MMO Reference: DCO/2019/00005  
Planning Inspectorate Reference: EN010117  
Identification Number: 20045232

## **Planning Act 2008, E.On Climate and Renewables UK Ltd, Proposed Rampion 2 Offshore Wind Farm Order**

### **Post-examination submission: Request for information from Secretary of State**

Figure 1. Predicted worst-case and mitigated (DBBC) behavioural response impact ranges (based on 135 dB SELss) for spawning herring from the piling of monopile foundations at the East and West modelling locations.

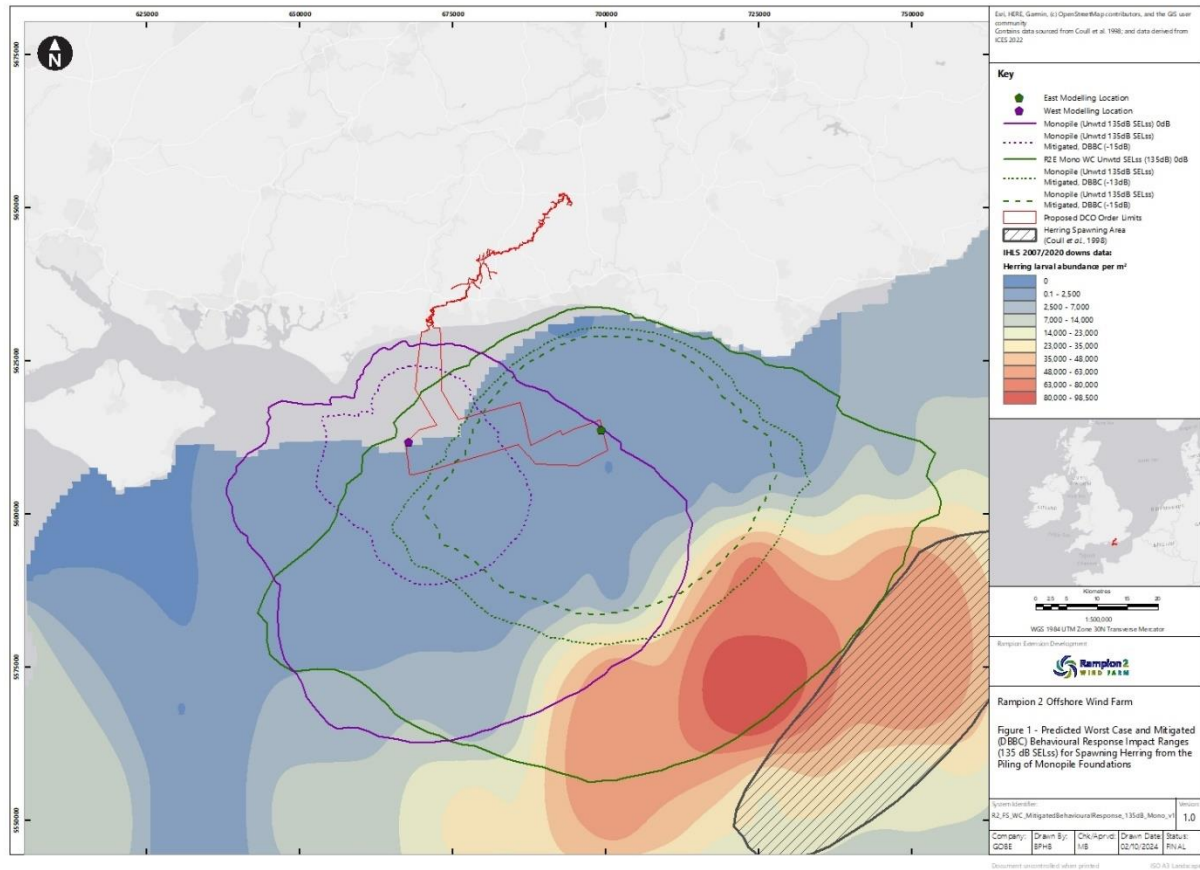
- 4.1.6 The updated modelling received via email (“Rampion 2 - Underwater noise and Herring”) and provided in Annex 1 of this Response Document show the mitigated and unmitigated noise contours for behavioural response impact ranges based on a 135 dB SELs for spawning herring from the piling of monopile foundations at the east and west modelling locations.

- 4.1.7 With regards to herring and potential disturbance to herring spawning from piling noise, the updated modelling shows that the range of impact to adult herring at their spawning grounds from underwater noise (UWN) can be reduced to an acceptable level.

- 4.1.9 In principle, now that the IHLS data used to form the aggregated larval abundance map has been clarified, and considering the updated UWN modelling as shown in Figure 1 and 2 in Annex 1, the MMO is generally content that a piling restriction during the Downs herring spawning season may not be necessary.

- 4.1.10 Whilst the MMO is content with the modelling provided, the results of the Applicant's noise monitoring at the post consent stage, particularly where foundations are installed in deeper water (>40m) locations, should be presented for review to demonstrate that a noise reduction of at least 13 dB can be achieved before this restriction can formally be removed.

Figure 3. Annotated predicted mitigated (DBBC -13 dB and -15 dB reductions) behavioural response impact ranges for spawning herring (based on 135 dB SELs) from the piling of monopile foundations at the West and South East modelling locations in the Western Array.

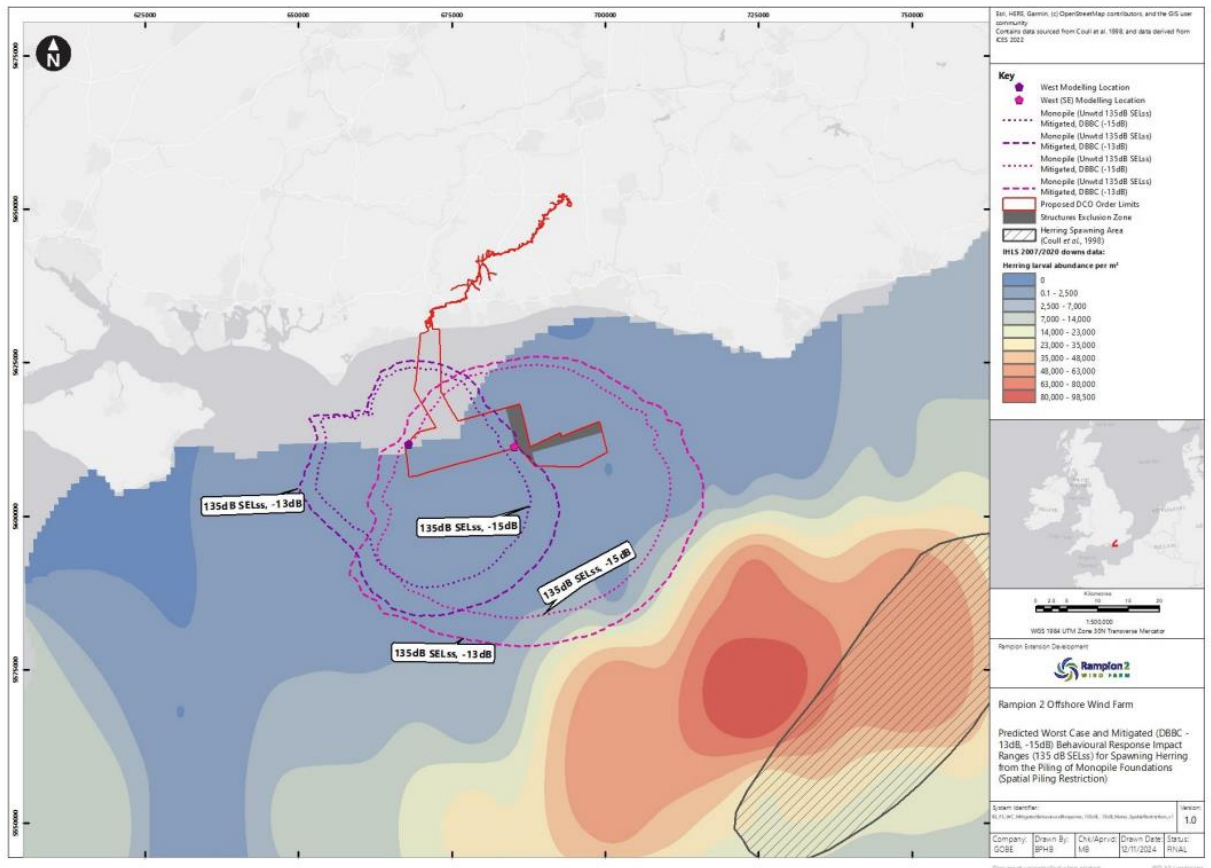
- 4.1.13 To support this Condition the Applicant included an annotated version of previous modelling showing mitigated noise contours for the West and South East modelling locations in the Western Array Area (Figure 3, Annex 2). The South East modelled location represents the nearest piling location within the Western Array, to the herring spawning ground as indicated by the larval abundance ‘heat’ map.

- 4.1.14 For the West modelling location mapped noise contours are presented for unmitigated 135 dB SELs, 135 dB SELs -13 dB mitigation (assuming a noise reduction of 13 dB), and 135 dB SELs -15 dB mitigation (assuming a noise reduction of 15 dB). For the South East modelling location mapped noise contours are presented for 135 dB SELs -13 dB mitigation and 135 dB SELs -15 dB mitigation, but there is no noise contour for the unmitigated 135 dB SELs.

- 4.1.15 It is unclear why the Applicant did not present the mapped noise contour for the unmitigated 135 dB SELs at the South East location, however, the MMO acknowledges that the Applicant has committed to the use of DBBC throughout the year, so on the assumption that a minimum reduction in noise of -13 dB can be achieved with DBBC, the overlap in noise disturbance will likely only affect a small portion of the herring spawning ground represented by low larval density on the ‘heat’ map (between 0.1 – 2,500 and 7,000 – 14,000 per square metre).

Figure 4. 'Outline Spawning Herring Piling Restriction Plan' West and East Array Areas, overlain with the respective predicted mitigated noise contours (-15 dB in the West Array Area and -13 dB in the East Array Area).

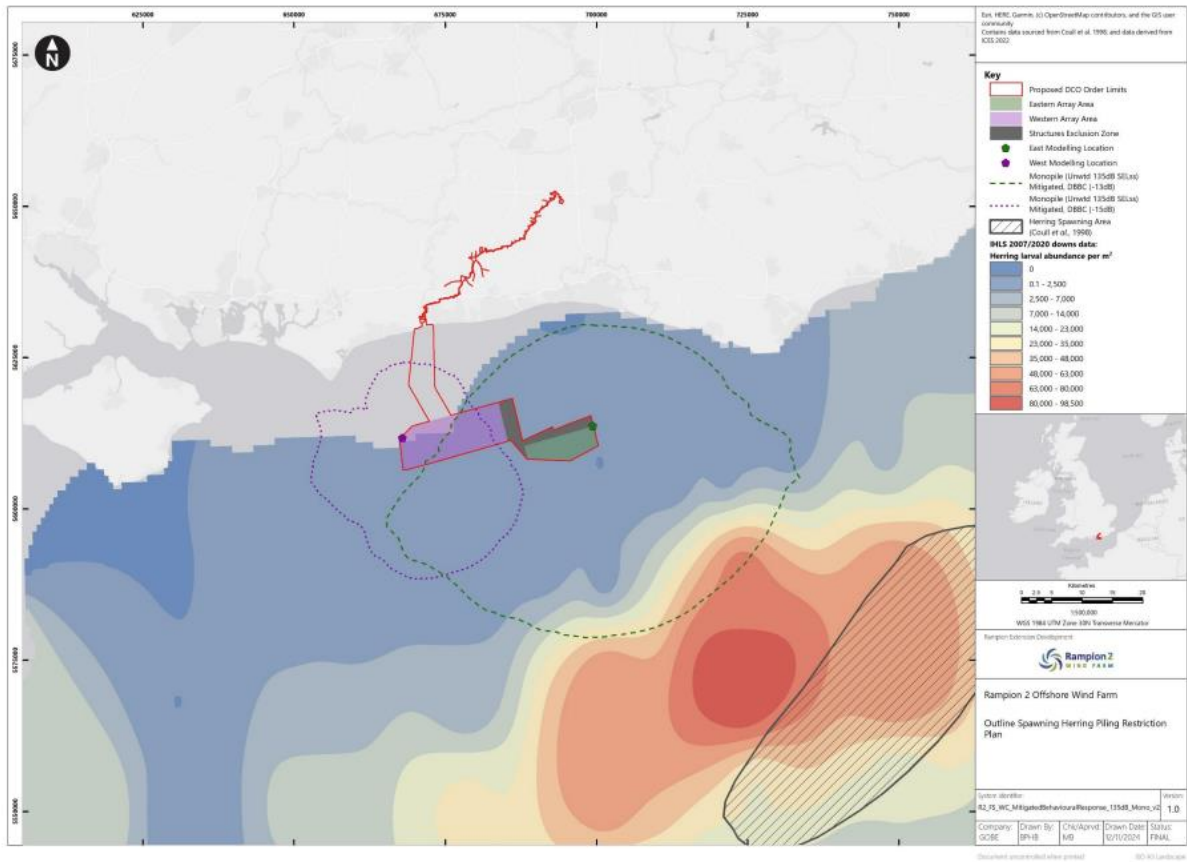
- 4.1.16 The Applicant has also provided an ‘Outline Spawning Herring Piling Restriction Plan’ (Figure 4, Annex 2) which the MMO believes they have provided to the SoS alongside the updated DML wording. This plan highlights the West and East Array Areas, overlain with the respective predicted mitigated noise contours (-15 dB in the West Array Area and -13 dB in the East Array Area). The MMO does request that the Outline Spawning Herring Piling Restriction Plan includes coordinates, so all parties are clear on the West and East Array Areas.

- 4.1.17 Based on the information provided, the MMO is reasonably content with the Applicant’s proposed Condition which proposes (minor amendment in blue above) that the spawning herring piling restriction plan only needs to be applied to the Eastern Array area.
